Access Compliance Report

Public Rights-of-Way

Intersection ID: 44449	Main Street: BAYVIEW_PY	Cross Street: PRESTBURY_BV	Location:	N
ADA ID: E5DCA2F028E2	Ramp Type: BlendTrans1	Initial Pass/Fail: Fail	Overall Compliance: No	Severity Score: 10

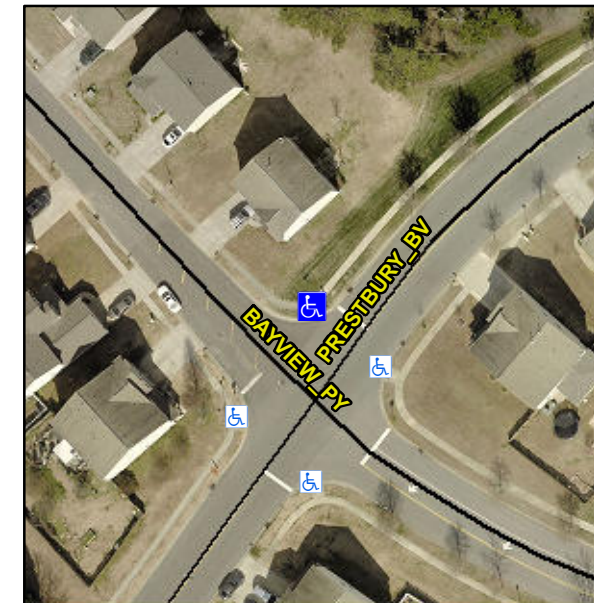
Not Found, R304.5.1, R304.5.3

Compliance	Description	Data	Compliance	Description	Data
N/A	Ramp Length (in)	64.0	Yes	BlendTrans Slope (%)	2.9
No	Ramp Width (in)	36.0	No	BlendTrans XSlope (%)	3.1
N/A	Flare Type LT	N/A	N/A	Flare Type RT	N/A
N/A	Flare Slope LT (%)	N/A	N/A	Flare Slope RT (%)	N/A
N/A	Flare Traversable LT?	N/A	N/A	Flare Traversable RT?	N/A
N/A	Landing Length (in)	N/A	N/A	DWS Provided?	N/A
N/A	Landing Width (in)	N/A	N/A	DWS Contrast?	N/A
N/A	Landing Slope (%)	N/A	N/A	DWS Length (in)	N/A
N/A	Landing X Slope (%)	N/A	N/A	DWS Full Width?	N/A
N/A	Landing Curb? (Y/N)	N/A	N/A	DWS Offset (in)	N/A
N/A	Shared Landing?	N/A			
N/A	Gutter Ponding?	N/A	N/A	Gutter Slope (%)	N/A
N/A	Gutter Lip Ht (in)	N/A	N/A	Gutter X Slope (%)	N/A
N/A	Painted X Walk1?	No	N/A	Painted X Walk2?	No
	X Walk 1 Direction	To SW		X Walk 2 Direction	To SE
	X Walk 1 Width (in)	N/A		X Walk 2 Width (in)	N/A
	X Walk 1 Slope (%)	2.4		X Walk 2 Slope (%)	1.8
	X Walk 1 X Slope (%)	1.2		X Walk 2 X Slope (%)	1.8

N/A	Ramp inside XWalk1?	N/A	N/A	Ramp inside XWalk2?	N/A
	Road Slope (%)	0.4		Clear Space?	N/A
	Road X Slope (%)	3.4	N/A	Clear Space to XWalk (in)	N/A
N/A	Any Obstructions?	N/A	N/A	Storm Grate/Utility Hazard?	N/A
	Obstruction Type			Storm Grate/Utility Type	
		N/A			N/A
			Yes	Surface Condition? (G/P)	Good
			No	Curb Slope (%)	9.5

Remove & Replace Curb Ramp With Two New Directional Ramps or Equivalent.
